ADDENDUM NUMBER 1

INVITATION TO BID #16-112-L

HVAC UNIT BILL JOHNSON PHYSICAL ACTIVITY BUILDING

April 18, 2016

ROOF PLAN - COMMUNITY ACTIVITIES BLDG.
SCALE: 1/8" = 1'-0"

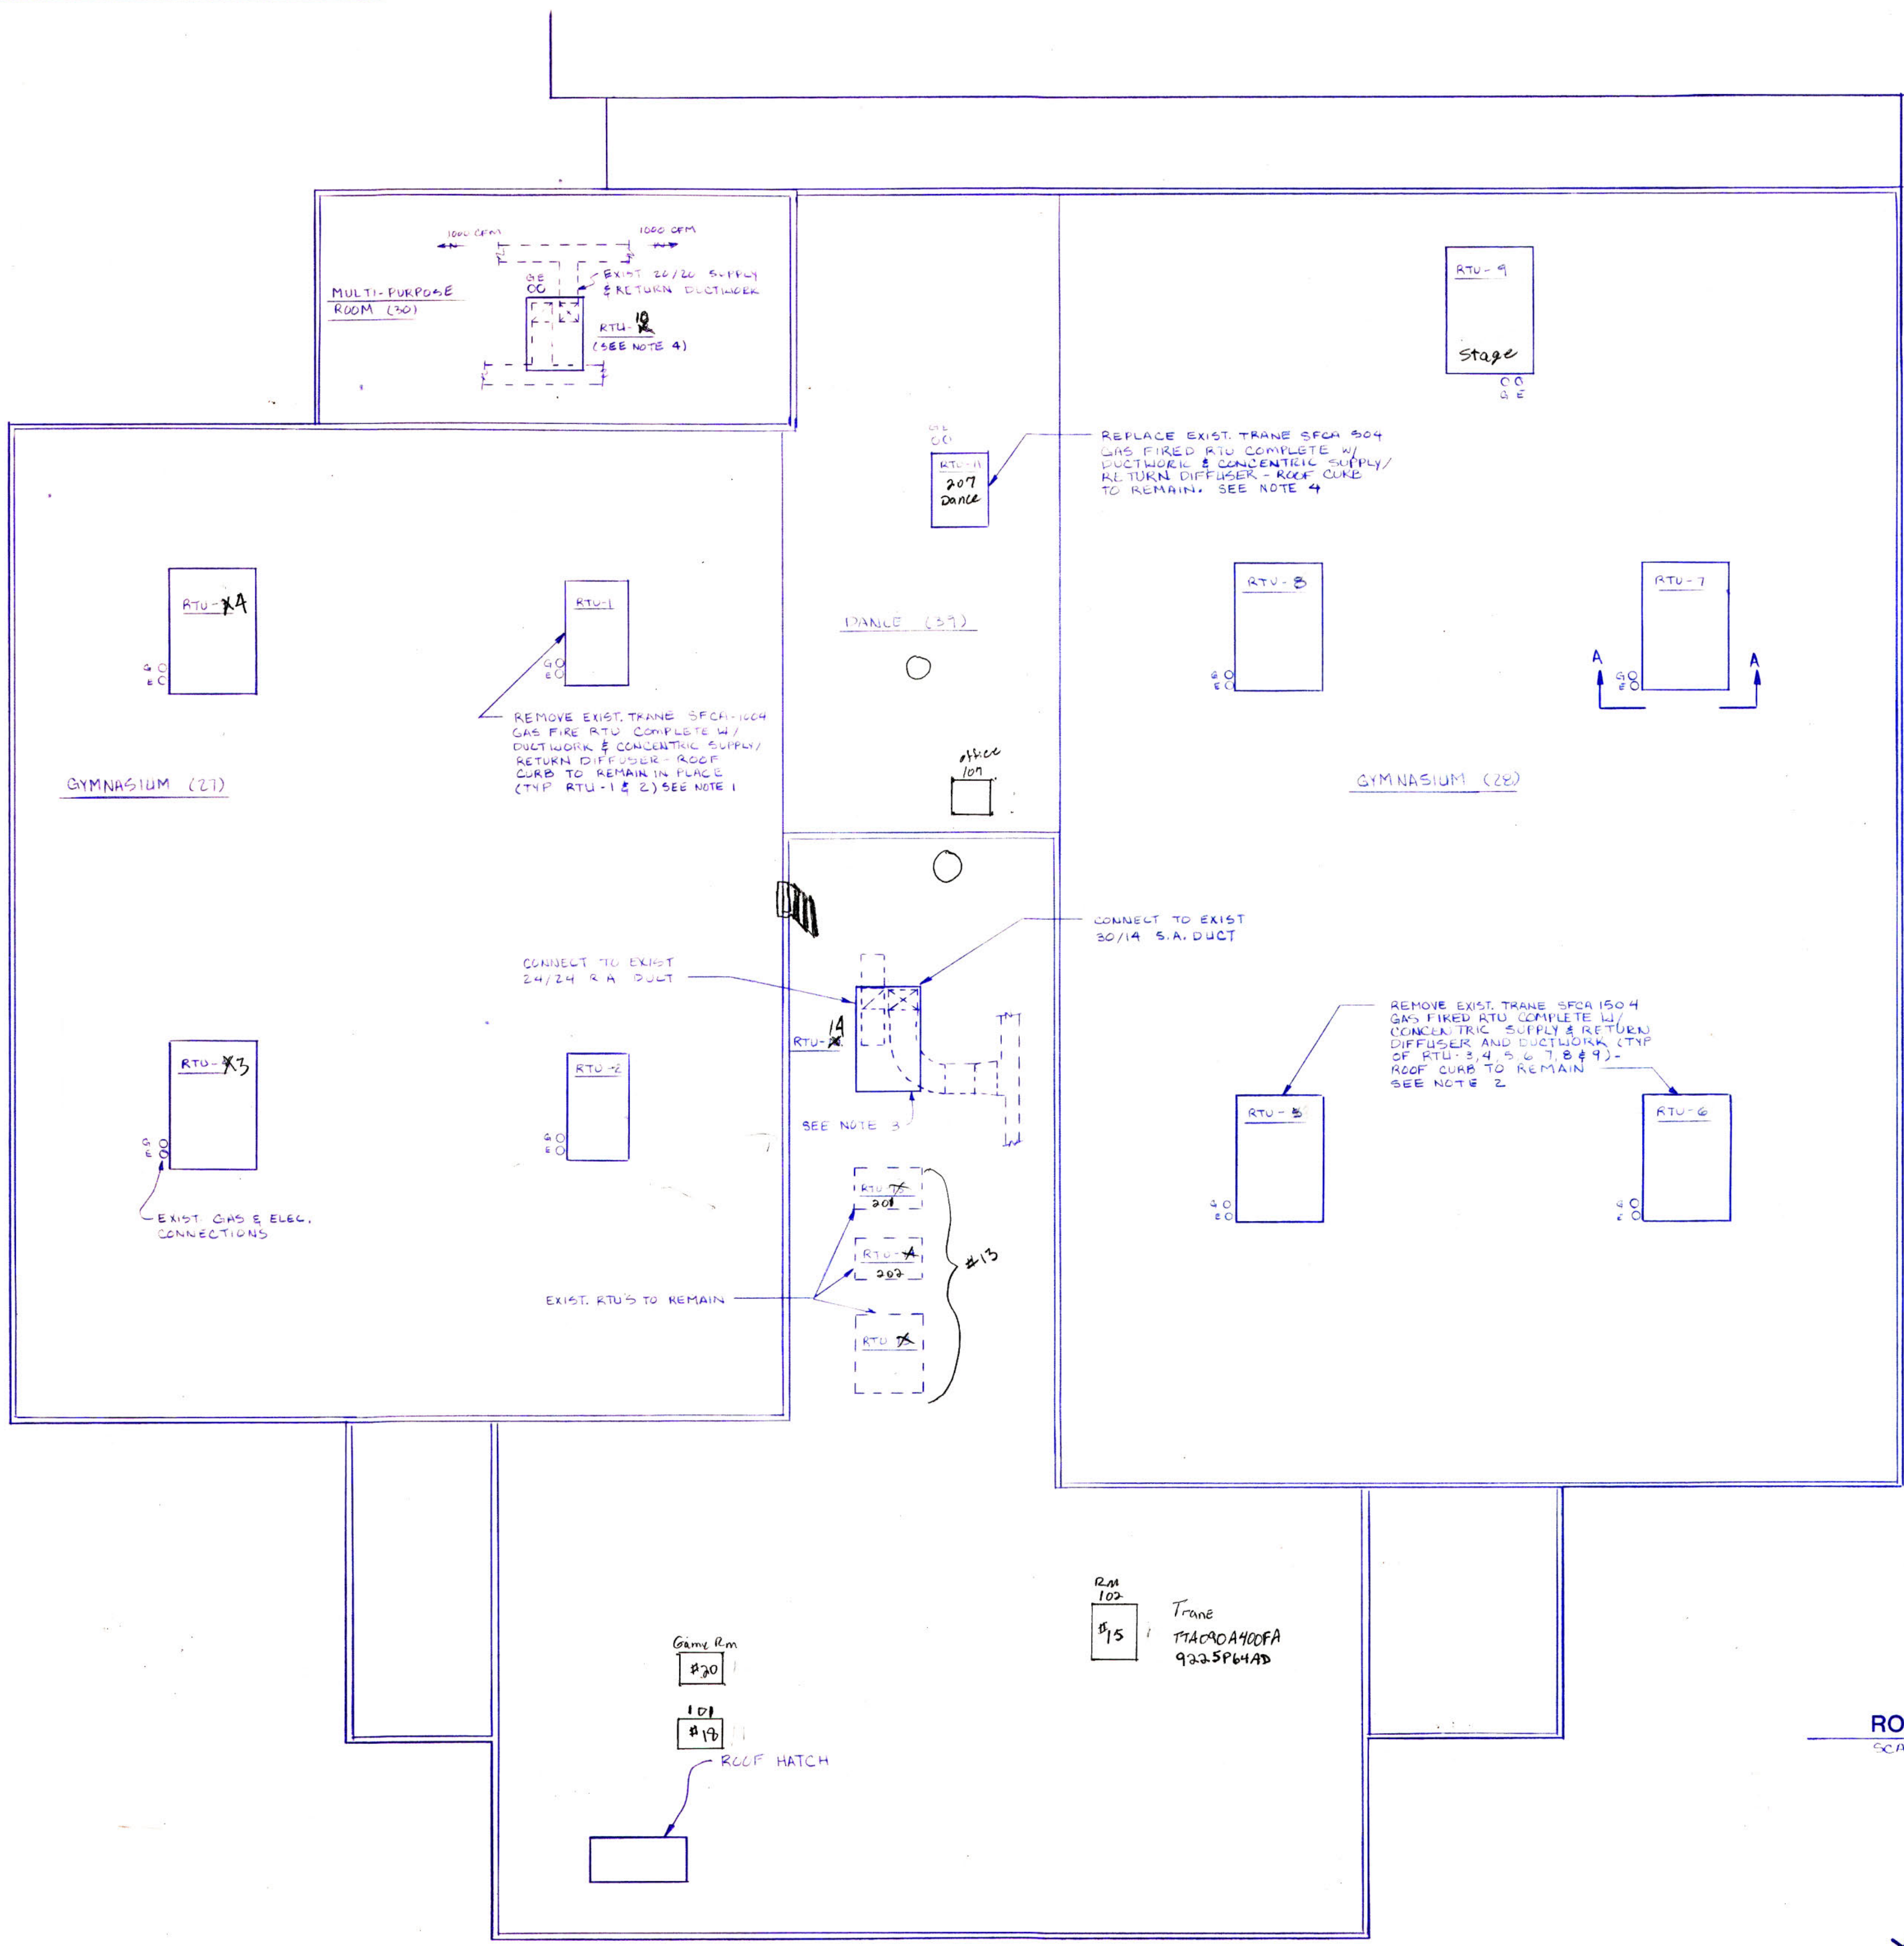
- What are the MERV ratings for the filters? (These specifications were not provided) Answer: Merv 7
- Are HVAC mechanical drawings available for the Community Activity Building A? If so, please provide. Answer: Drawing attached to Addendum
- Page 27, Appendix A – Standard Forms – Please provide clarification on whether the supplied “Contract Agreement” is the “Sample Contract” listed under the bid submittal requirements. Answer: Sample Contract
- Page 27, Appendix A – Standard Forms – Is a Bond Capacity Letter acceptable for the Sample Payment and Performance Bond? Answer: A payment and performance bond will only be required at the time of award.
- Can you tell me what the Georgia Offerors License Prequalification is and if you need one for this bid? Answer: Not required
